F3 Freeway to Branxton link

Independent Design Review: Conditions of Approval 53 and 54

**AusLink National Network
F3 to Branxton link**

**Independent Design Review
Conditions of Approval 53 and 54**

Figure 2 Newcastle interchange vegetation changes

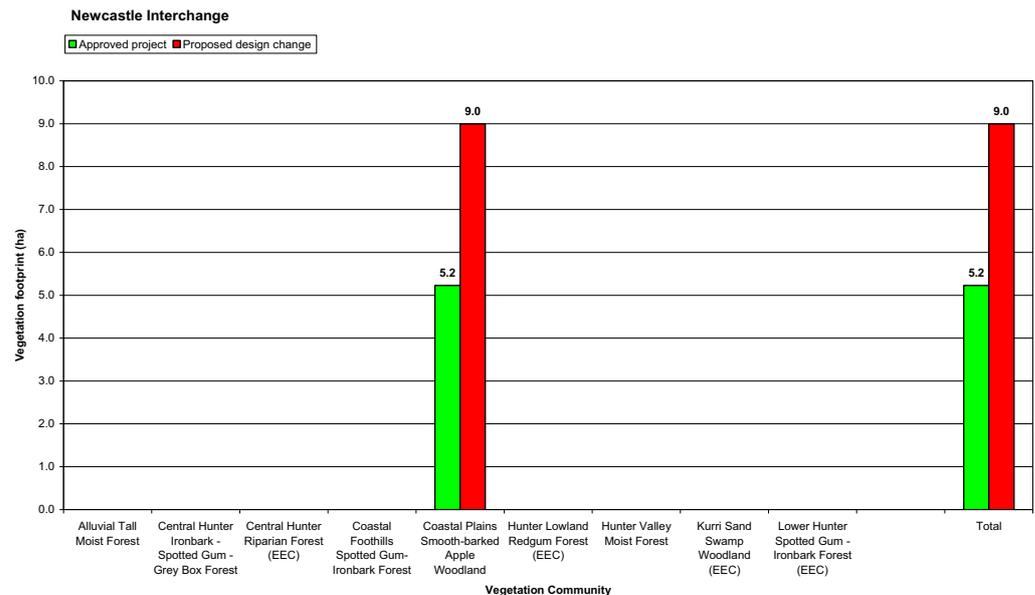
Figure 2 shows that the proposed design change would increase clearing. However, as noted in Section 1.7, the vegetation clearing for the Approved Project is understated. Importantly, the connectivity along Minmi Creek would be improved, and the impacts on associated Aboriginal objects and European relics would be reduced, due to the replacement of a 130 m long culvert by four bridges.

This area falls within a DEC regional corridor, which extends from east of Mount Sugarloaf to the 'Tank Paddock'. It is described as the ridge running east-northeast from Mount Sugarloaf, together with the waterways and riparian areas north (Blue Gum Creek) and south (Minmi Creek) of the ridge. The proposed bridges over Minmi Creek would allow uninterrupted fauna movement across the Link within this recognised fauna corridor and would provide greater connectivity than the Approved Project. Improved connectivity in this area is considered more important than a slight increase in vegetation clearing of moderate quality Coastal Plains Smooth-barked Apple Woodland. The proposed design change at the Newcastle interchange is considered likely to reduce impacts on ecological values when compared to the Approved Project.

The proposed design change would provide a desirable level of service for a freeway-to-freeway connection.

The potential traffic conflict would be caused by a low volume of weaving vehicles. The RTA is currently investigating a change to the Newcastle Link Road/Cameron Park Drive intersection to address the traffic issues raised by the independent road designer. This change is not a part of the F3 to Branxton link and will be assessed separately.

Figure 3 Sugarloaf realignment vegetation changes

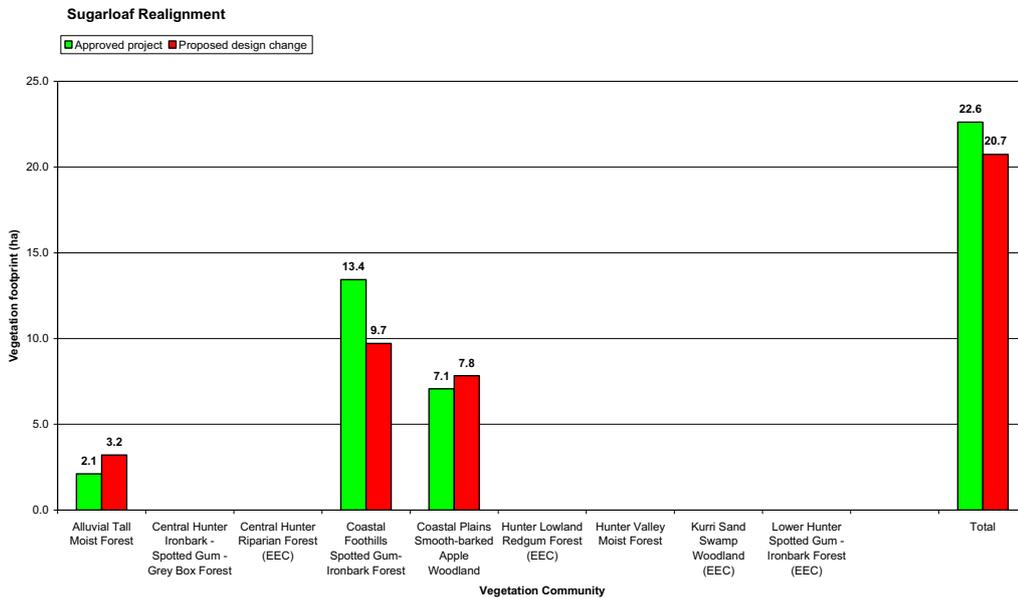
In addition to the improved fauna connectivity, Figure 3 shows that the proposed design change would have a positive ecological outcome because it would reduce clearing. The proposed design change in the Sugarloaf Range is considered likely to reduce impacts on ecological values when compared to the Approved Project.

As described above, Stockrington Ridge forms part of a regional corridor identified by the DEC. The proposed design change would pass through an expanse of open forest at Stockrington Ridge, which extends from Awaba State Forest in the south to the edge of Hexham Swamp in the north. This area is already fragmented to a degree by numerous forestry tracks, electricity transmission lines and George Booth Drive, although these barriers would be passable to more mobile terrestrial fauna.

Figure 4 Surveyors Creek realignment vegetation changes

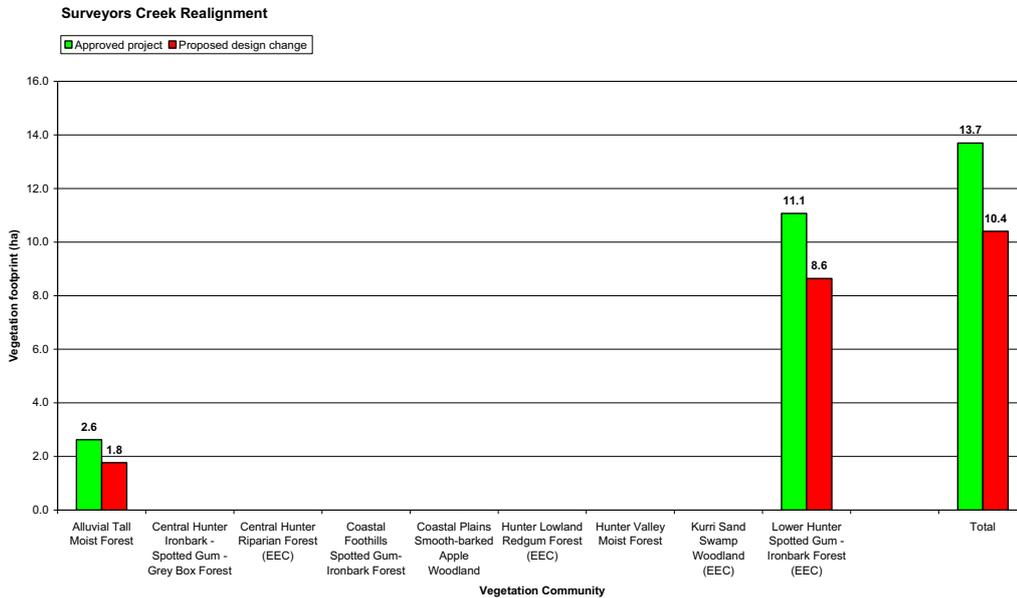
No threatened plant species were recorded within the footprint of the proposed design change. However, Lower Hunter Spotted Gum-Ironbark Forest, which is listed as an EEC on the TSC Act, would be affected. The Powerful Owl *Ninox strenua* has previously been recorded in this section (Harrington, et al 2007), and Squirrel Gliders have been detected in the vicinity of the Sugarloaf Range (Connell Wagner 1997). Figure 4 shows that the proposed design change would have a positive ecological outcome because it would reduce clearing.

The provision of permanent water supply ponds for animals is not required due to the proximity of existing water supplies and the difficulties in maintaining suitable water quality.

The proposed design change would provide satisfactory road geometry.

Figure 5 Buchanan interchange vegetation changes

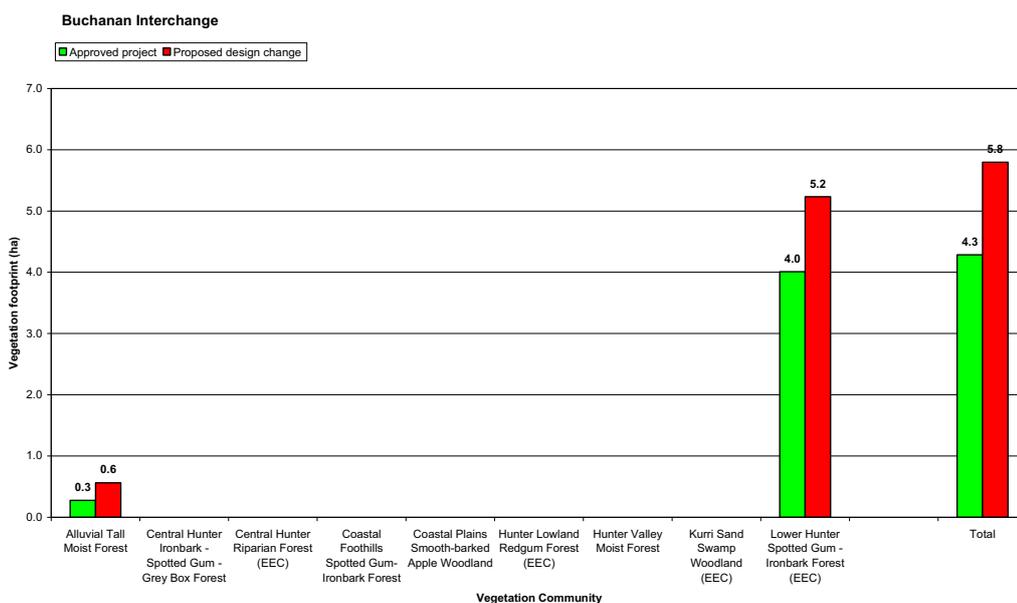
Figure 5 shows that the proposed design change would increase vegetation clearing. As noted in Section 1.7, the actual vegetation clearing is likely to be reduced. Despite the indicated increase in clearing area, the proposed design change would have a positive ecological outcome when compared to the Approved Project.

The proposed design change would produce a more compact and more conventional interchange layout.

Figure 6 Averys Lane overpass vegetation changes

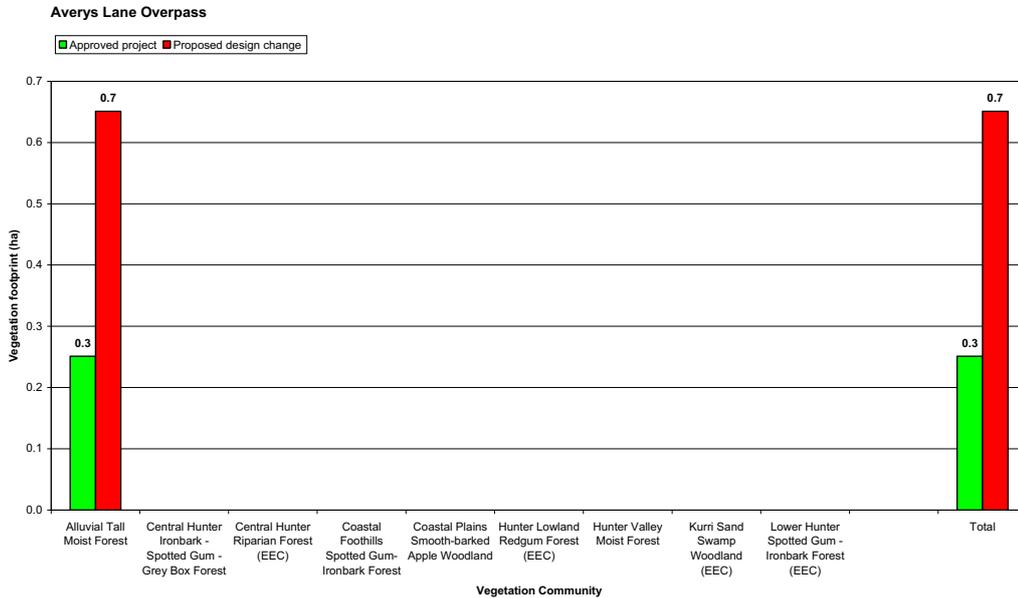
No threatened plant species or EECs were recorded under the footprint of the design change for Averys Lane. No threatened animal species have been previously located near the Averys Lane Overpass. Figure 6 shows that the proposed design change would increase vegetation clearing by 0.4 ha in the Alluvial Tall Moist Forest vegetation community.

The key trigger appears to justify the proposed design change.

Figure 7 Kurri Kurri interchange vegetation changes

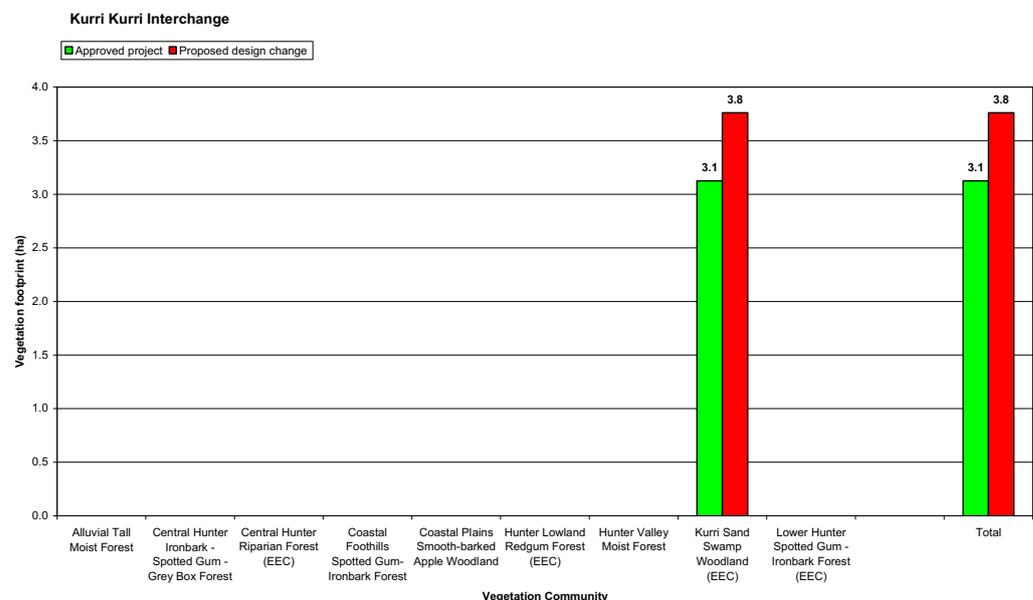
Figure 7 shows that the proposed design change would increase clearing. As noted in Section 1.7, the actual vegetation clearing is likely to decrease. The proposed design change would close Stanford Road and should increase connectivity within the adjacent patches of Kurri Sand Swamp Woodland, when the section of road south of the Link is revegetated. The closure of the section of Stanford Road south of the Link may also reduce rubbish dumping within the adjacent Kurri Sand Swamp Woodland, because it would remove direct vehicle access.

Despite the indicated increase in the clearing area in Kurri Sand Swamp Woodland, the proposed design change would have a positive ecological outcome when compared to the Approved Project.

The proposed design change would produce a more compact and more conventional interchange layout. It would also rationalise the interchange's traffic movements.

However, it is noted that the proposed design change would eliminate the connection to Stanford Road.

The RTA notes the comments of the independent ecologist and road designer. Closure of Stanford Road would reduce clearing of, and ongoing impacts on, Kurri Sand Swamp Woodland. The environmental impacts of the closure of Stanford Road are assessed in a separate report (Acacia Environmental Planning 2007).

Figure 8 McLeod Road overpass vegetation changes

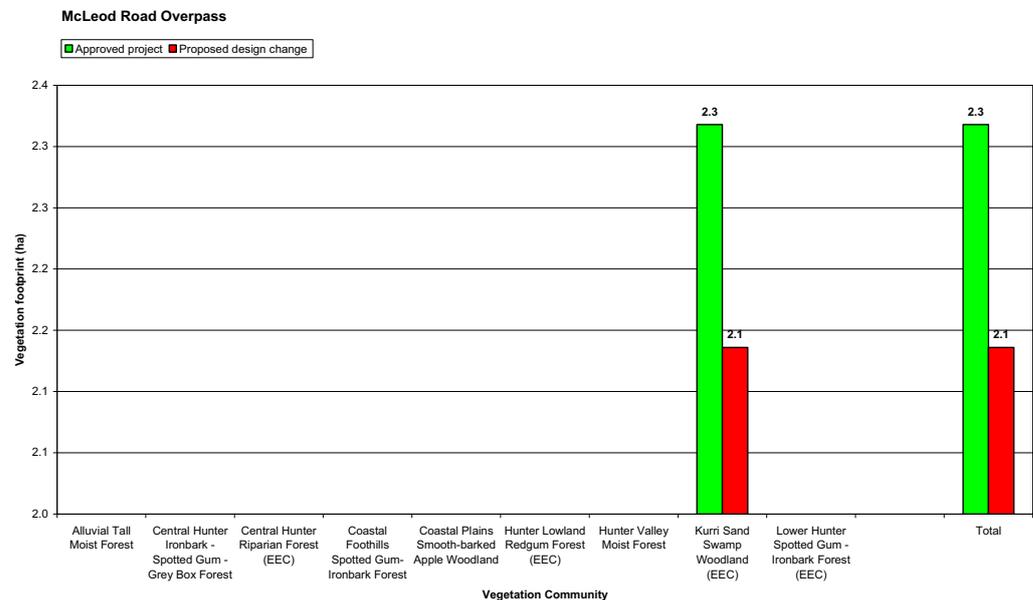
The proposed design change would affect two small fragmented patches of good quality Kurri Sand Swamp Woodland. Roads, electricity easements, residential housing and a wastewater treatment plant surround the two patches of vegetation. Figure 8 shows that the proposed design change would have a positive ecological outcome because it would reduce clearing.

The key trigger appears to justify the proposed design change.

Figure 9 Swamp Creek vegetation changes

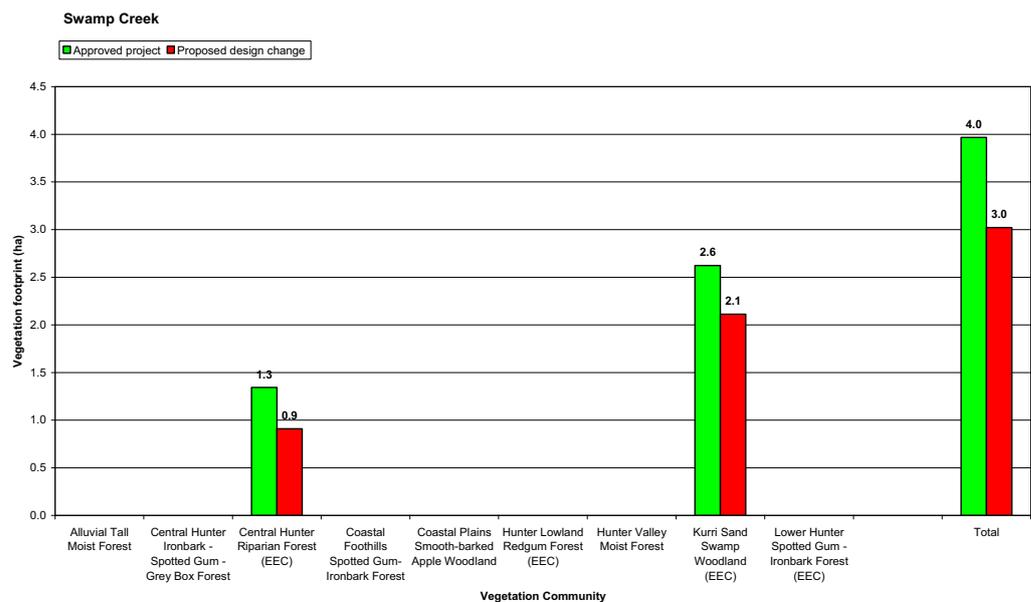
The proposed design change would affect moderate quality Kurri Sand Swamp Woodland and Central Hunter Riparian Forest. Figure 9 shows that the proposed design change would have a positive ecological outcome because it would reduce clearing.

The proposed design change would create more desirable vertical geometry in the vicinity of the South Maitland Railway crossing.

The RTA notes the comments of the independent ecologist and road designer.

Figure 10 Loxford interchange vegetation changes

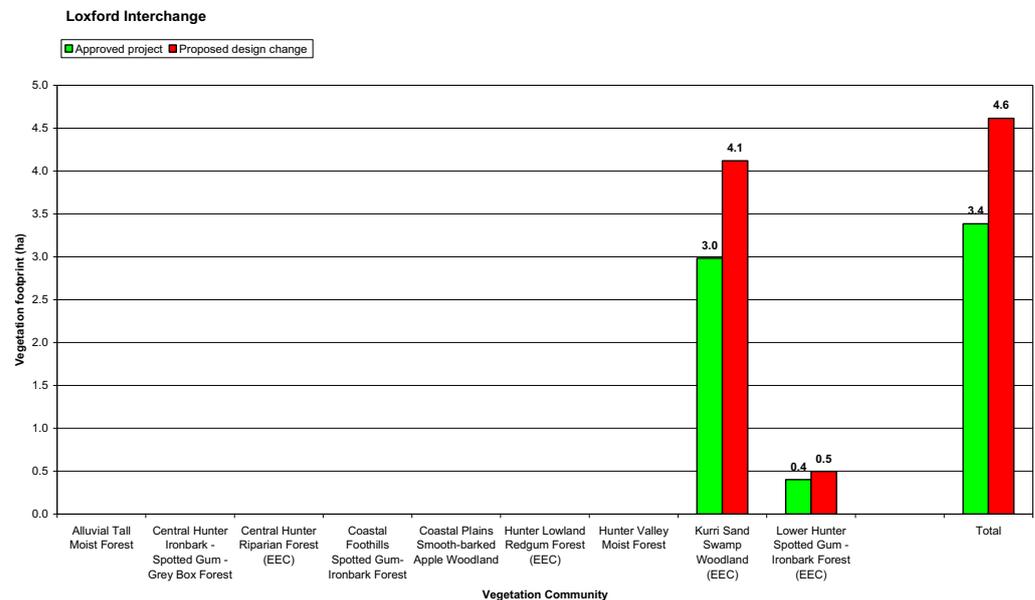
Figure 10 shows that the proposed design change would increase clearing. As noted in Section 1.7, the actual vegetation clearing is likely to be unchanged. Despite the indicated increase in clearing, the proposed design change is unlikely to worsen the ecological outcome when compared to the Approved Project.

The key trigger appears to justify the proposed design change.

The RTA notes the comments of the independent ecologist and road designer.

Figure 11 Sawyers Gully realignment vegetation changes

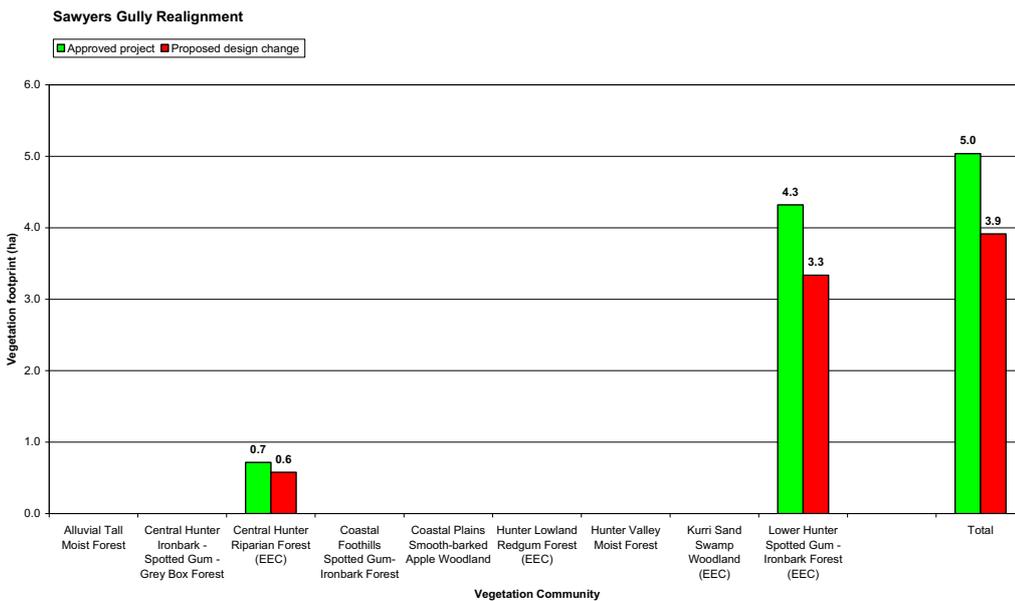
Riparian Forest. Figure 11 shows that the proposed design change would have a positive ecological outcome because it would reduce clearing.

The proposed design change would provide satisfactory road geometry.

The key trigger of construction under traffic appears to justify the change to the alignment of Old Maitland Road.

The RTA notes the comments of the independent ecologist and road designer.

Figure 12 Allandale interchange vegetation changes

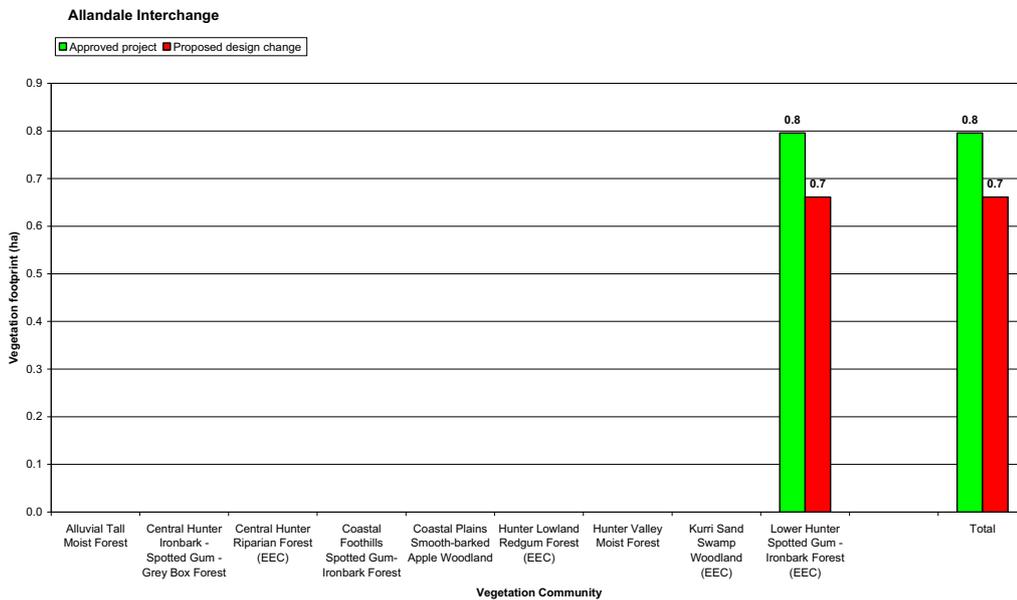
The proposed design change would affect the edges of a small patch of moderate quality Lower Hunter Spotted Gum-Ironbark Forest. Figure 12 shows that the proposed design change would have a positive ecological outcome because it would reduce clearing.

The key trigger appears to justify the proposed design change. Access to the Allandale Quarry and to the proposed Anvil Creek development would be improved.

The RTA notes the comments of the independent ecologist and road designer.

Figure 13 Camp Road underpass vegetation changes

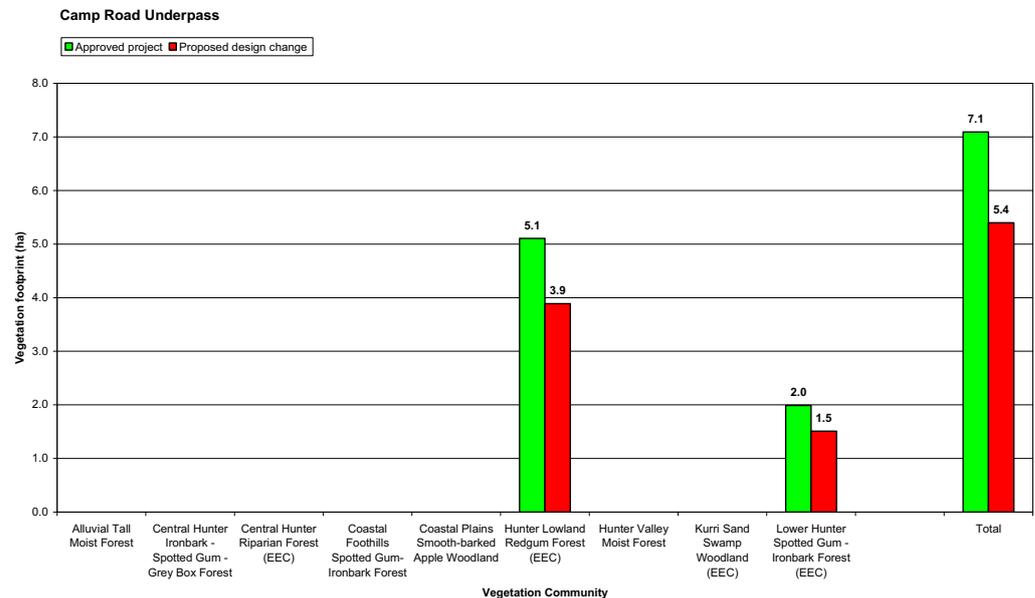
No threatened plant species were recorded within the footprint of the proposed design change. However, Hunter Lowland Redgum Forest and Lower Hunter Spotted Gum-Ironbark Forest, both EECs on the TSC Act, occur immediately adjacent to the new alignment. Squirrel Gliders have been previously recorded in the surrounding forest patches (Connell Wagner 1997, DEC Atlas of NSW Wildlife). Figure 13 shows that the proposed design change would have a positive ecological outcome because it would reduce clearing.

The proposed design change presents a less desirable solution from an engineering perspective. However, it is an acceptable alternative.

Figure 14 Tuckers Lane to Black Creek vegetation changes

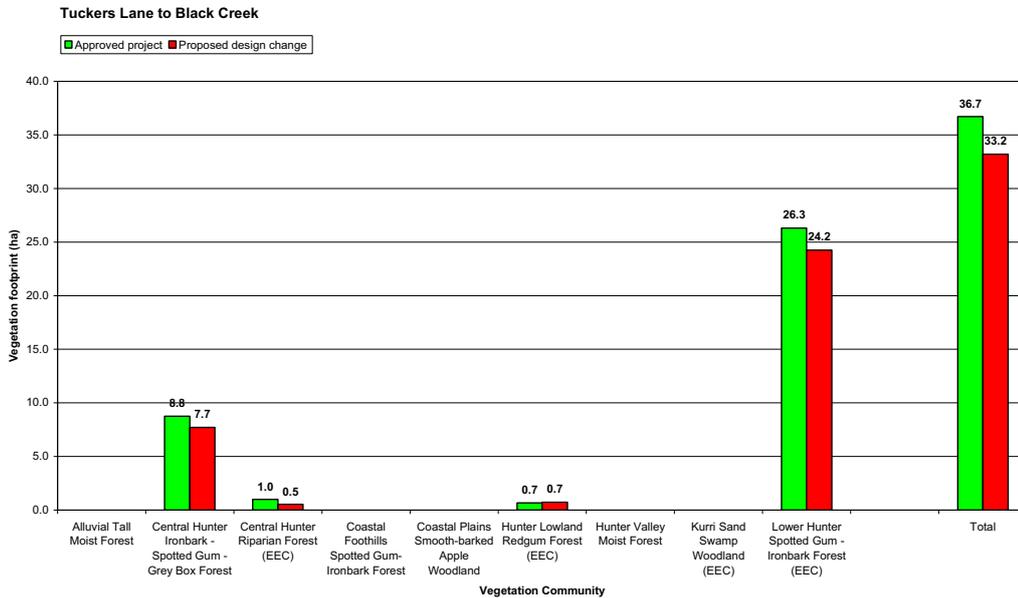
The proposed design change would affect moderate quality Lower Hunter Spotted Gum-Ironbark Forest and Central Hunter Ironbark - Spotted Gum-Grey Box Forest, and poor quality Hunter Lowland Redgum Forest, as well as Central Hunter Riparian Forest along Anvil and Black Creeks. The proposed design change at Branxton would have a positive ecological impact because it would reduce clearing in two of the three EECs. Figure 14 shows that the proposed design change would have a positive ecological outcome because it would reduce clearing.

The proposed longitudinal fauna corridor at the Tuckers Lane bridge is unlikely to increase connectivity as Tuckers Lane is a narrow gravel country road and the likelihood of road kill is low. The longitudinal fauna corridor is likely to be a greater hindrance to wildlife movement than Tuckers Lane. Macropods, birds and gliders that would move throughout the area are unlikely to use the fauna corridor to cross Tuckers Lane. Given the poor condition and existing fragmentation of fauna habitat on either side of Tuckers Lane, it is unlikely that smaller animals would move through this area. A longitudinal fauna corridor at Tuckers Lane is not supported.

The proposed longitudinal fauna corridor at the Wine Country Drive bridge is also unlikely to increase faunal connectivity. Agricultural land occurs to the east of Wine Country Drive at this point; it separates the woodland patches on either side and would hinder fauna movements. Additionally, like the situation at Tuckers Lane, no threatened species other than the Grey-crowned Babbler are present in the vicinity. Macropods, birds and gliders that would move throughout the area are unlikely to use the fauna corridor to cross Wine Country Drive. Given the poor condition and existing fragmentation of fauna habitat on either side of Wine Country Drive, it is unlikely that smaller animals would move through this area. The majority of fauna crossing Wine Country Drive would do so to the south of the fauna corridor, at North Rothbury, where the woodland is continuous (although thin). A longitudinal fauna corridor at Wine Country Drive is not supported.

The geometry of the main carriageway of the proposed design change would be similar to the Approved Project.

The left-in/left-out connection to the west of Branxton would provide more access control and therefore improves the road safety.
